December 23, 1992
LD-92-123

Docket No. 52-002

Subject: Closure of System 80+™ Draft Safety Evaluation Report Issues

Figure 2.5.2.5.1-4.1 - Spectral match of time history and CMS1 target spectrum
 (Horizontal Direction, Time History 1, Damping 1, 2, 5, 7%)

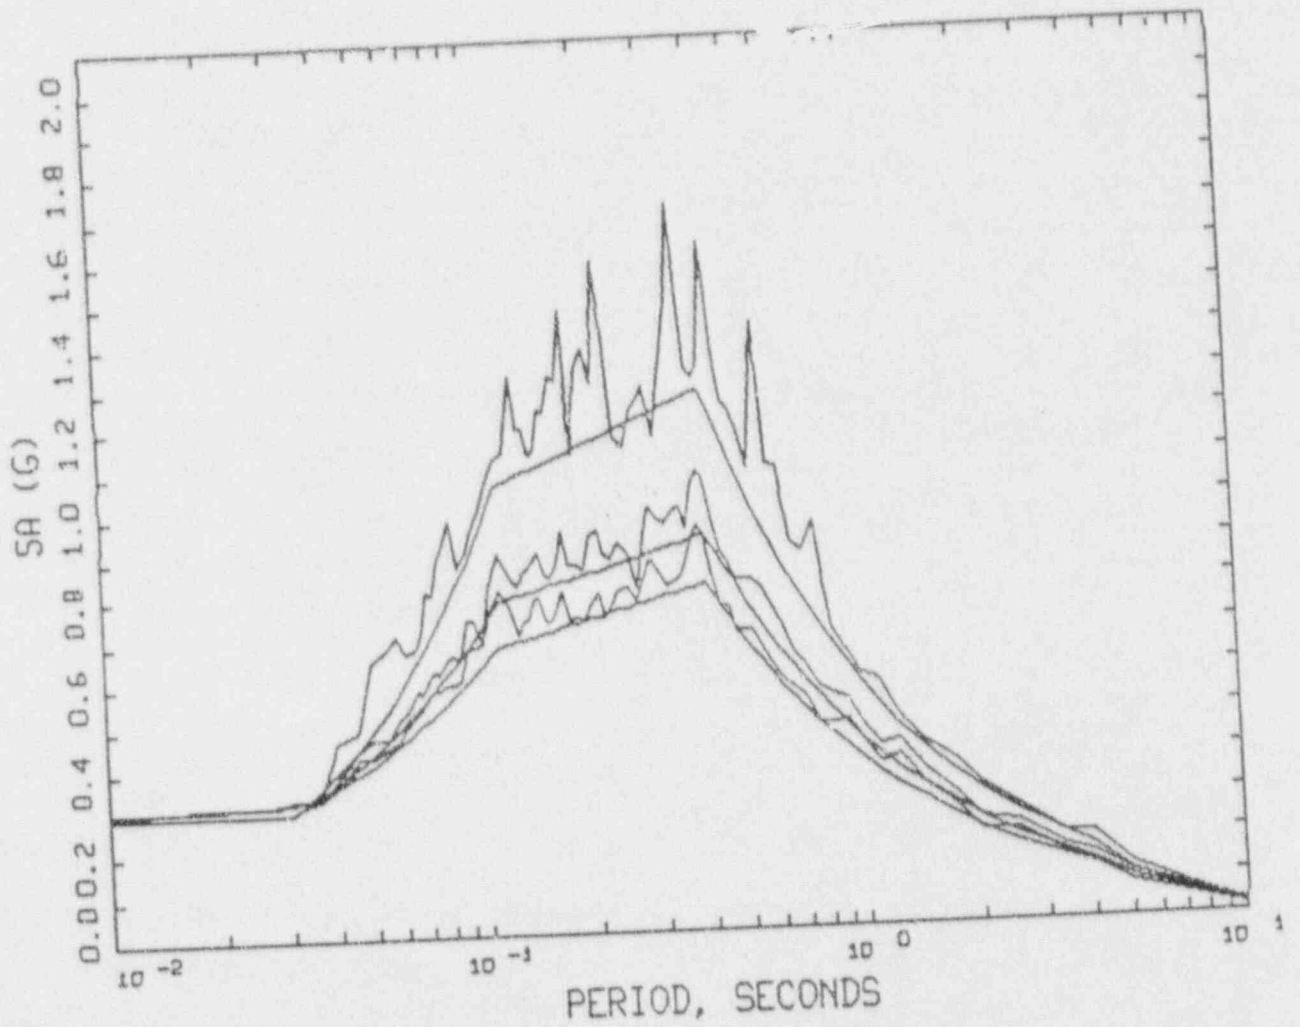
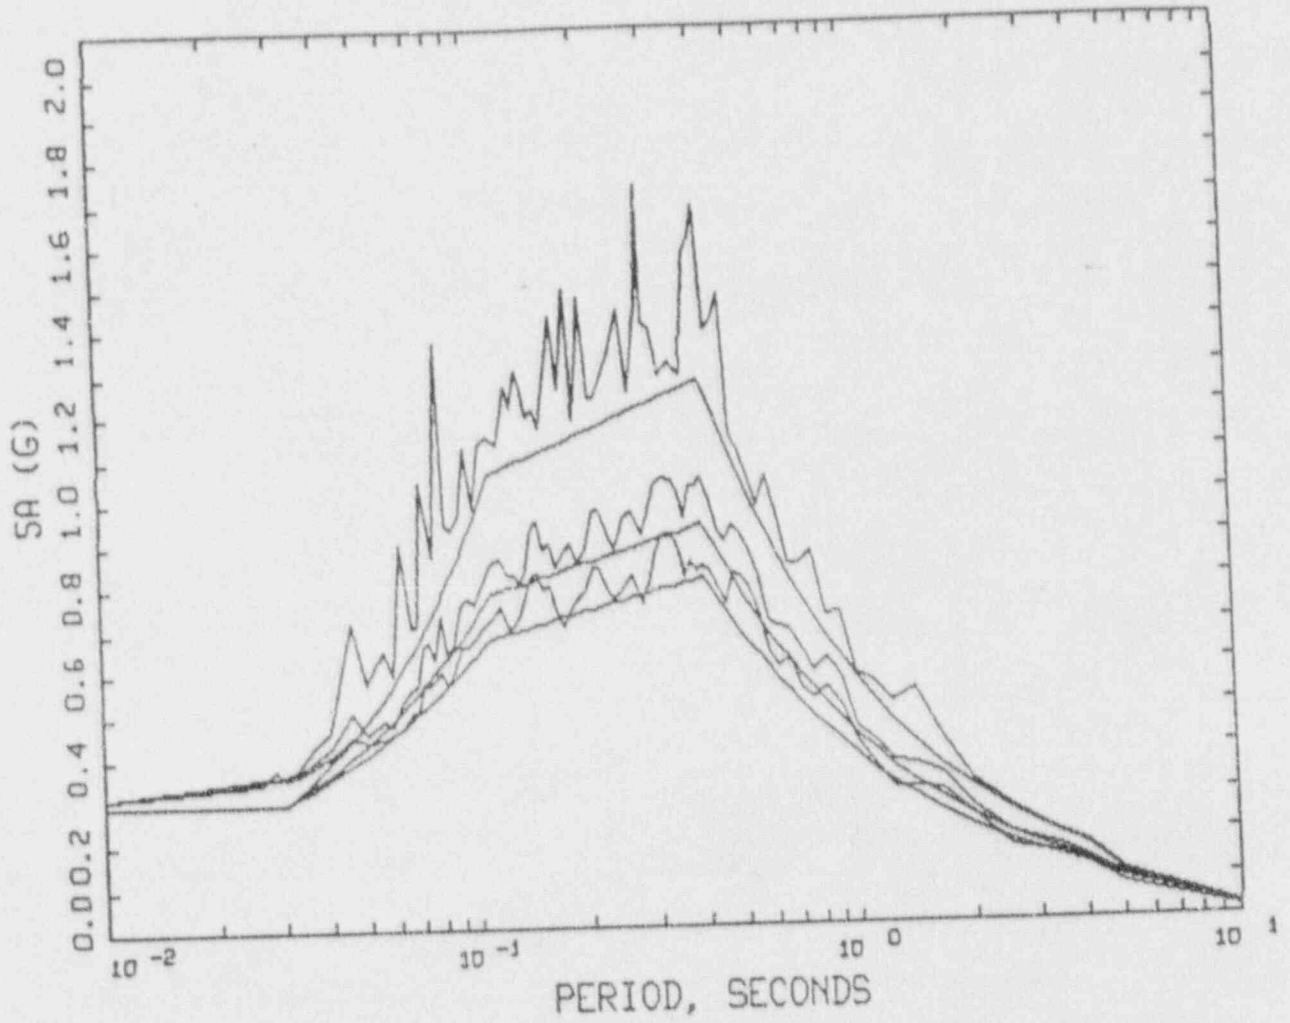
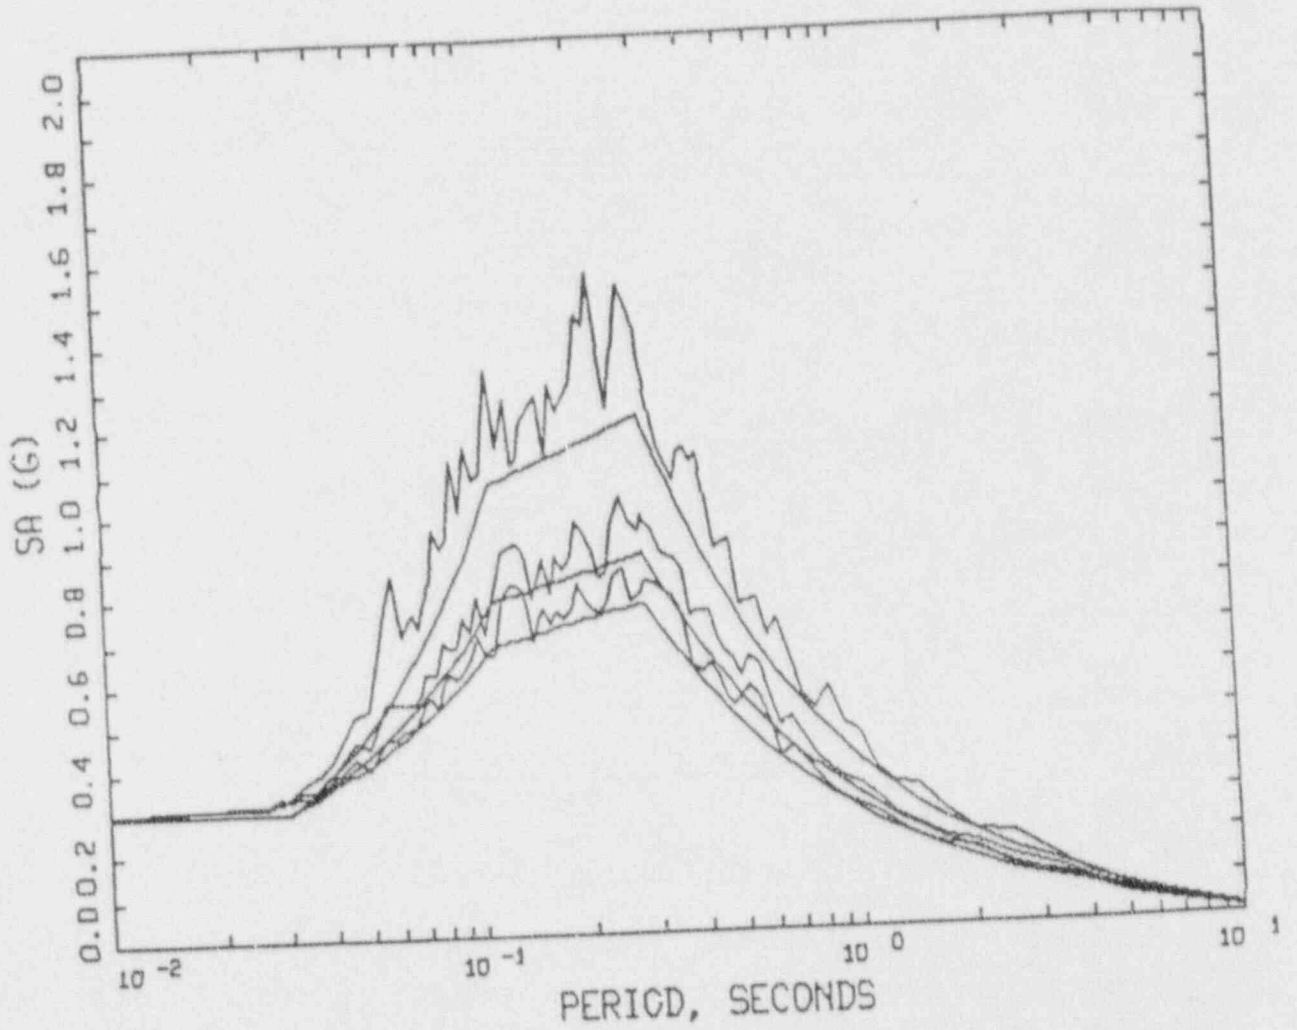
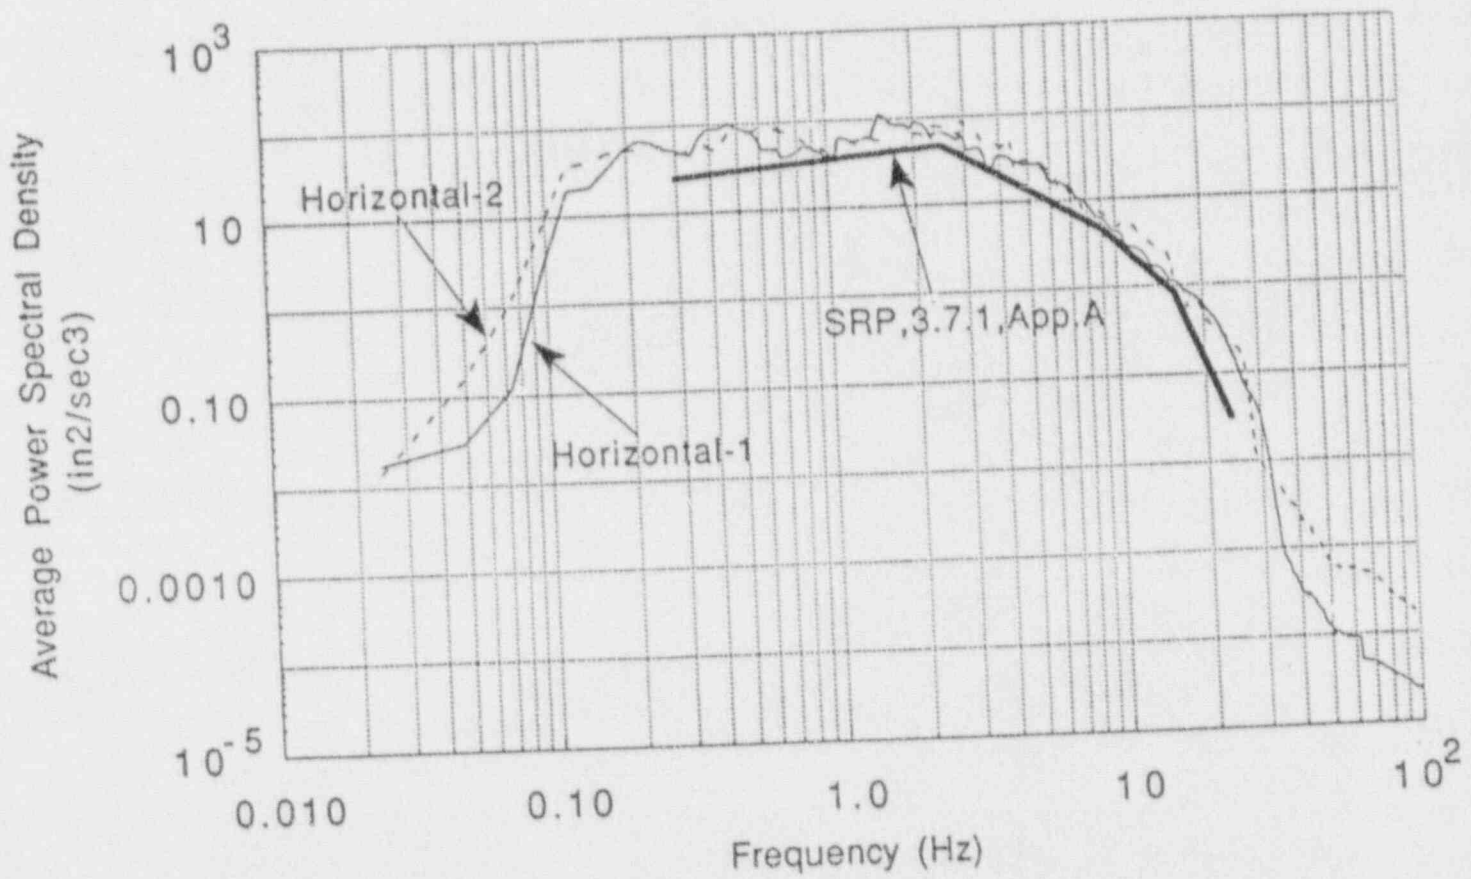
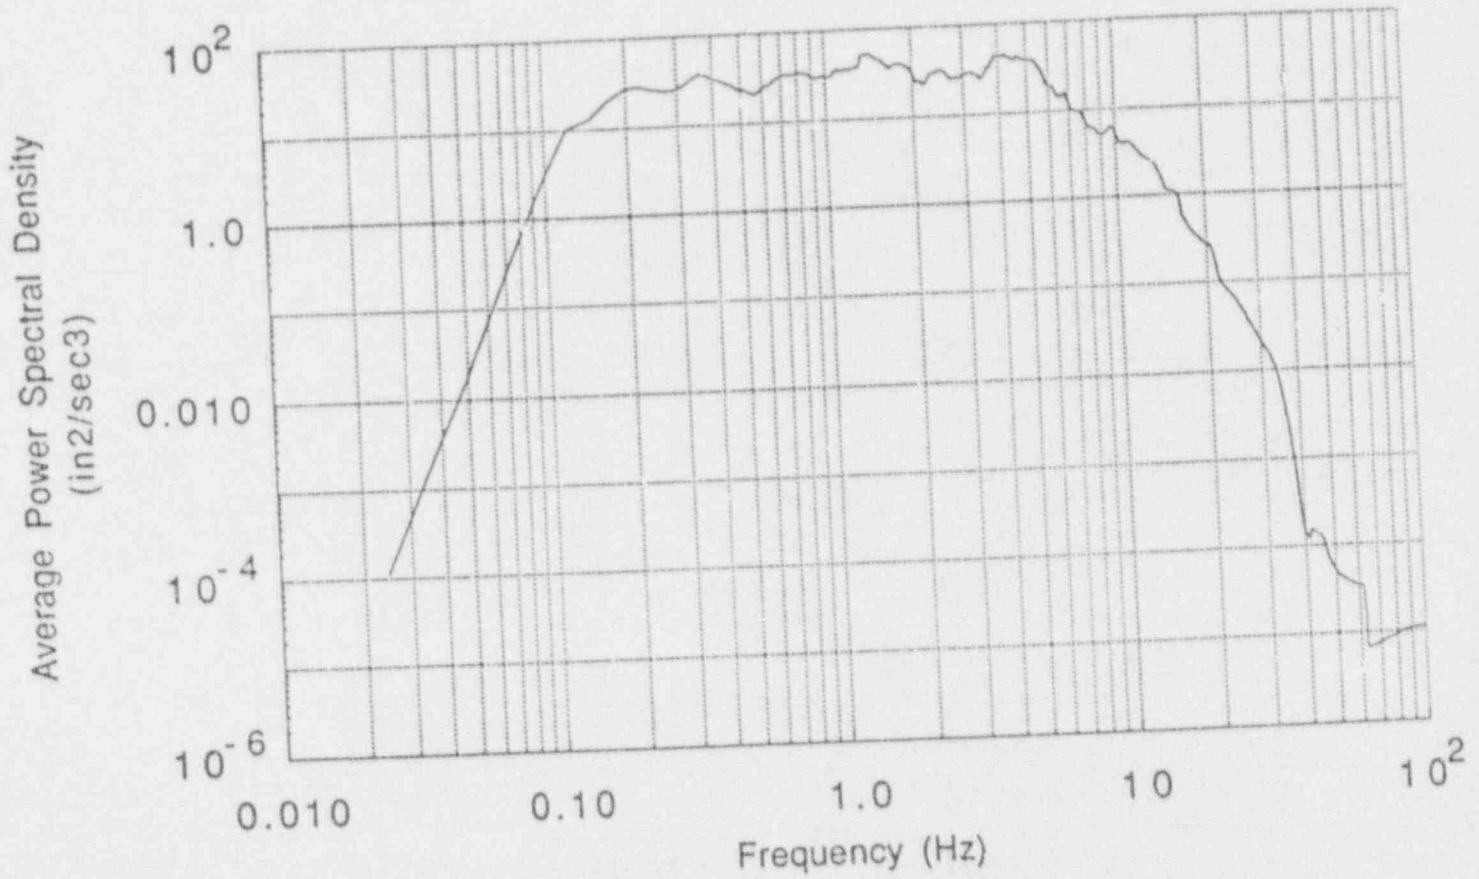
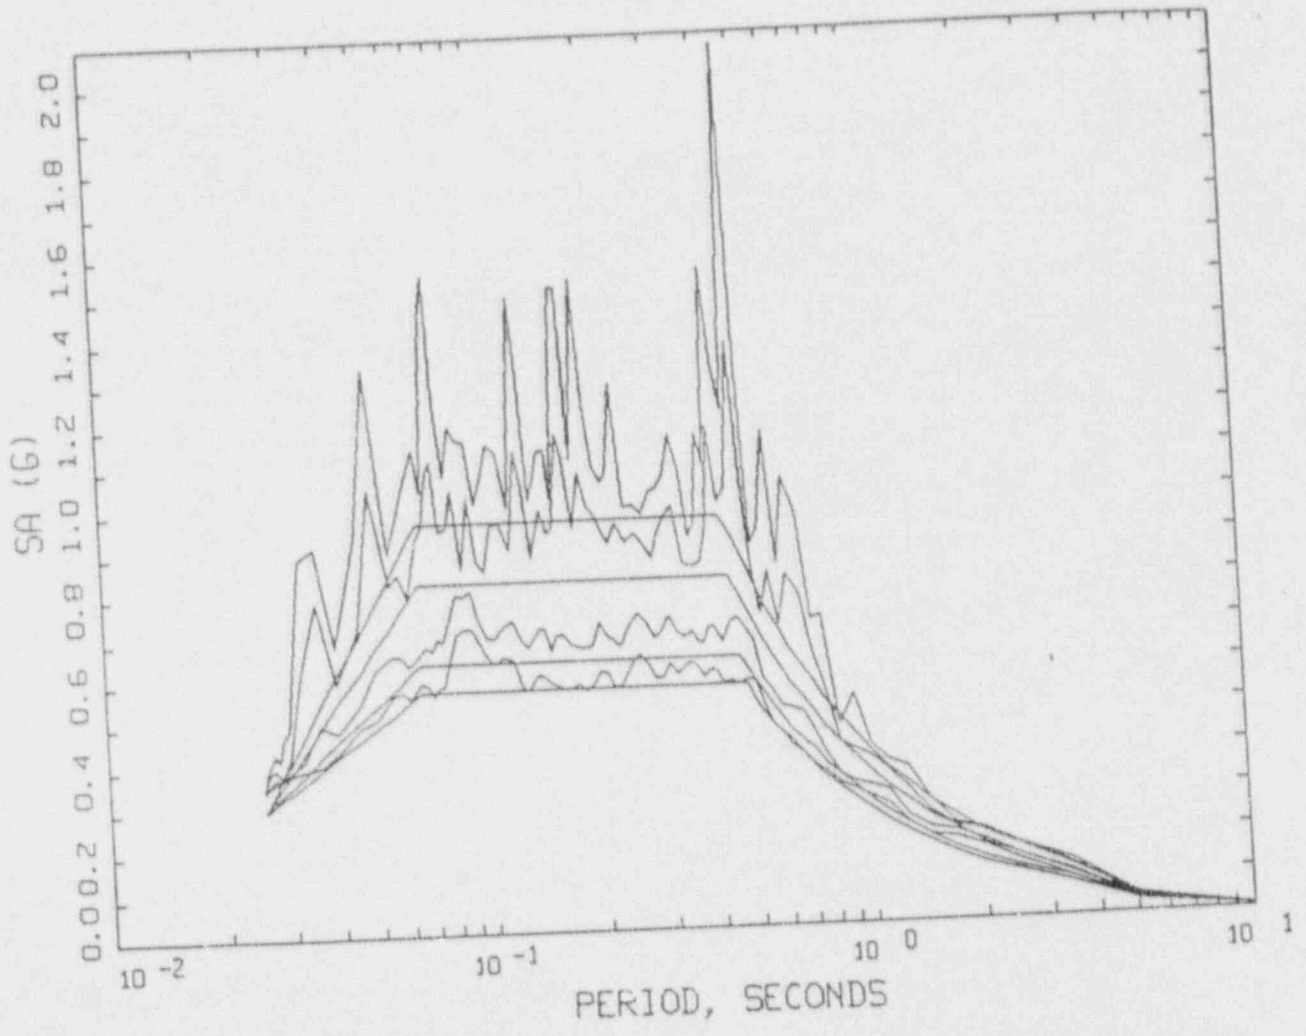
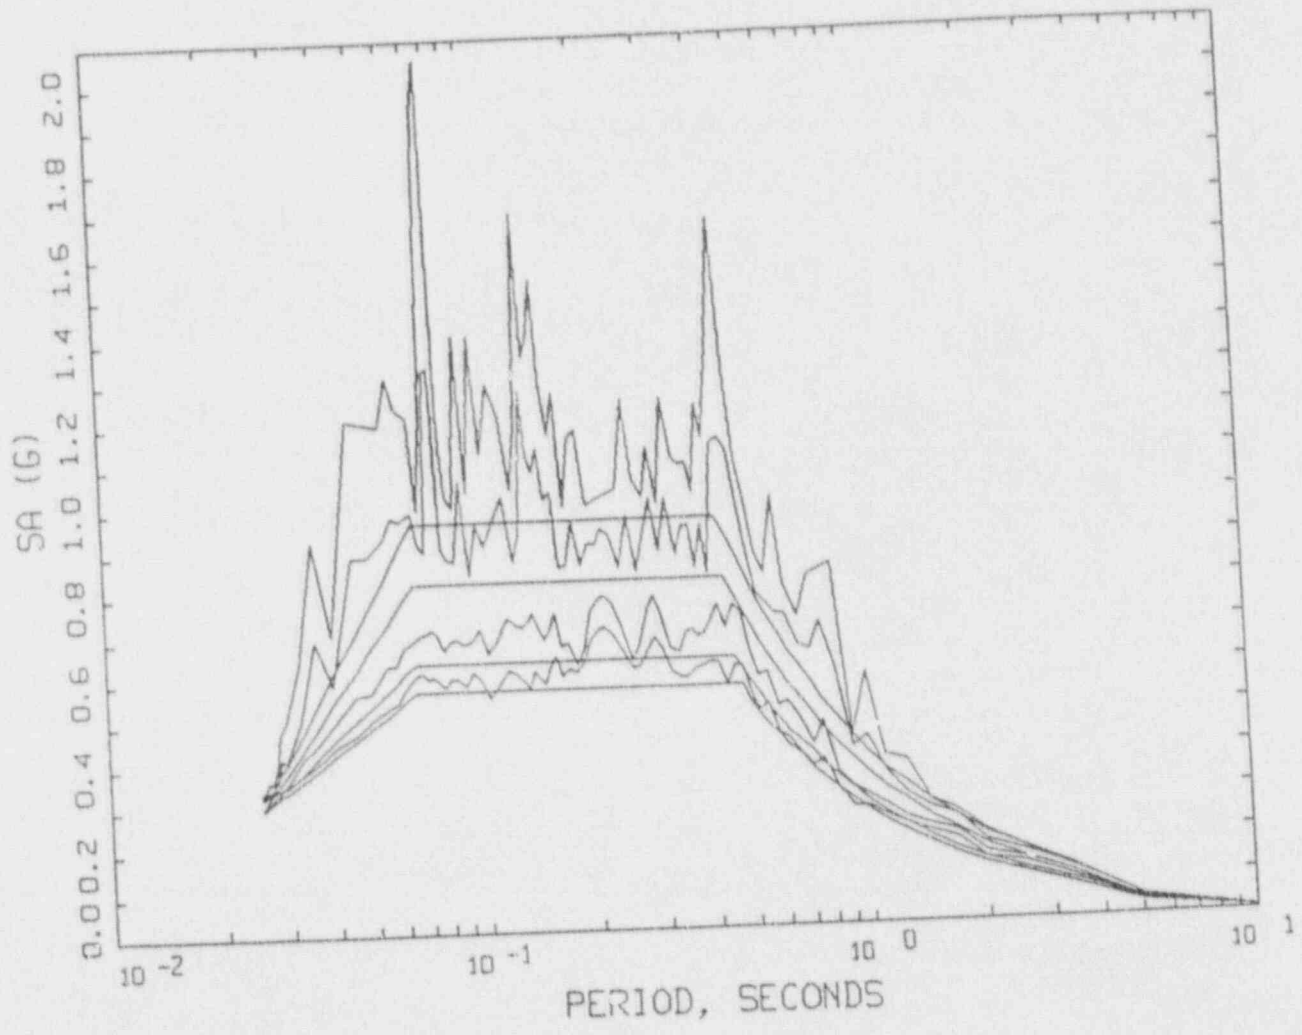
The CESSAR should be revised to include CMS1 and CMS3.

The CESSAR is being revised to include the CMS1 and CMS3 time histories, the corresponding spectra match at 1, 2, 5 and 7% damping and the CMS1 and CMS3 Power Spectral Densities. Figures 2.5.2.5.1-4.1 through 2.5.2.5.1-4.11 show the information that will be included in the CESSAR. All time histories meet the SRP criteria for development of artificial time histories. CMS1 meets the SRP 3.7.1, App. A requirements for Power Spectral Density (PSD) for the horizontal motions, as shown in Figure 2.5.2.5.1-4.4. In addition, it is shown in Figures 2.5.2.5.1-4.5 and 2.5.2.5.1-4.8 through -11 that the PSD of the vertical CMS1 time history and all three time histories of the CMS3 motion have adequate PSD's with no deficiency in power at any frequency range.
